Incident ID	nAPP2200730406
District RP	
Facility ID	
Application ID

Site Name: EAST PECOS FEDERAL 22 #009H	Site Type: Oil Production Site
Date Release Discovered: January 4 th , 2022	API# (if applicable) 30-015-43349

**Re: Remediation Work Plan Addendum
East Pecos Federal 22 #009H
Incident Numbers NVV2003433576, NRM1935238930, NRM2001038937 and
nAPP2200730406
Eddy County, New Mexico**

SOIL SAMPLE LOCATIONS

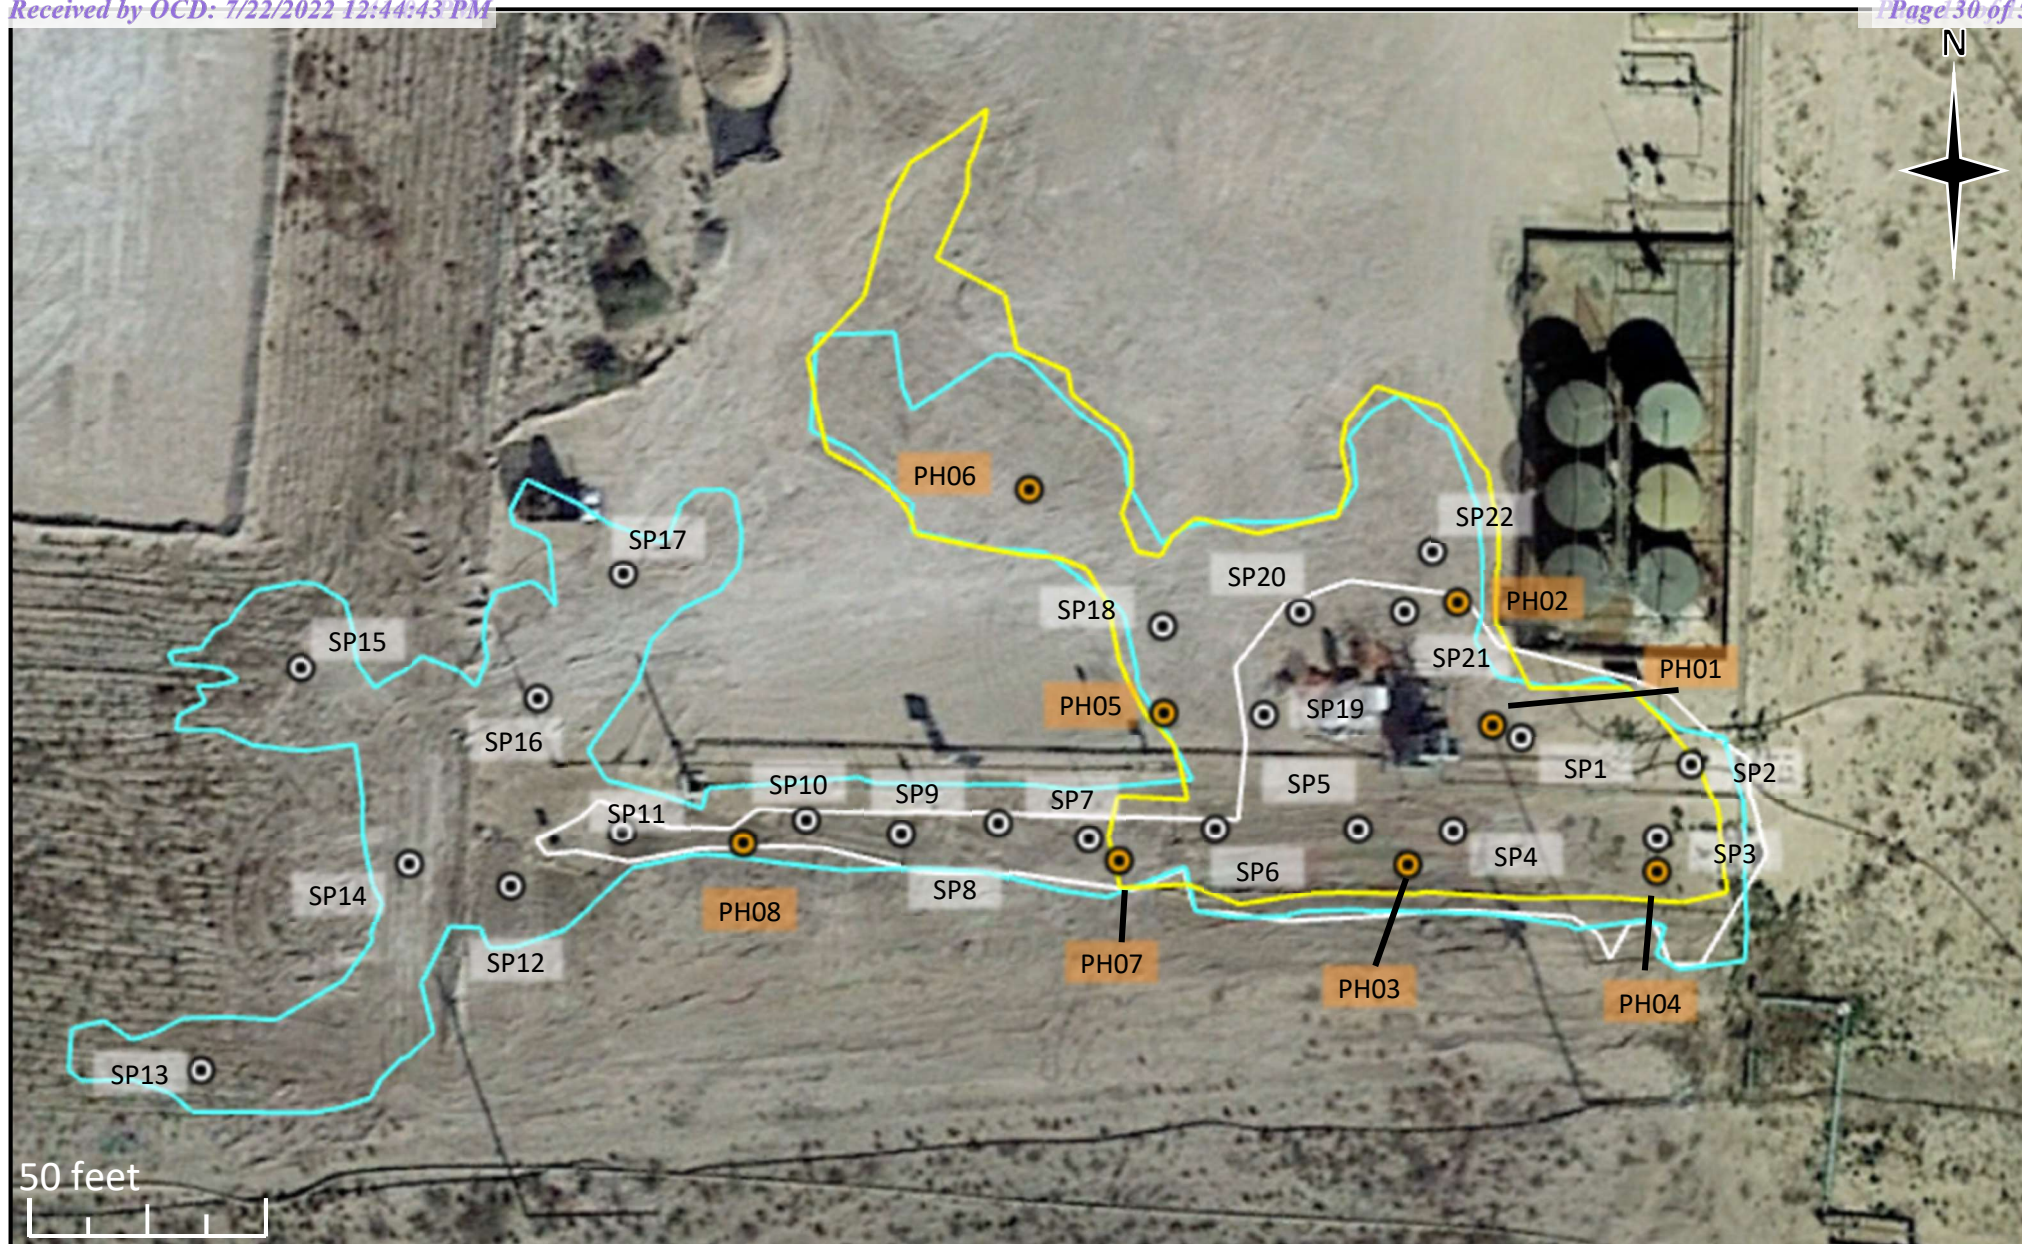
- Based on laboratory analytical results associated with delineation soil samples PH03 and PH04 and surface soil samples SS02 and SS04, concentrations of contaminants of concern (COCs) greater than the NMOCD Closure Criteria will be excavated and sampled in accordance with the Closure Criteria and/or Reclamation Standard (**See Figure 2 in Appendix A**);

- Based on laboratory analytical results associated with delineation soil samples on pad (PH01) and off pad (SP12 through SP15), COCs are greater than the applicable NMOCD Closure Criteria and/or Reclamation Standard and will require remediation. Additionally, an off-pad area to the southeast will be addressed as proposed in the original RWP (**See Figure 3 and 4 in Appendix A**);
- Based on current delineation soil laboratory analytical results and extent of the release areas, an estimated **1,550 cubic yards** of impacted soil are anticipated to be remediated and/or removed from the Site for disposal in accordance with state and federal regulations;
- Based on laboratory analytical results for delineation soil samples on pad (excluding PH01) no remediation efforts are required in these areas.
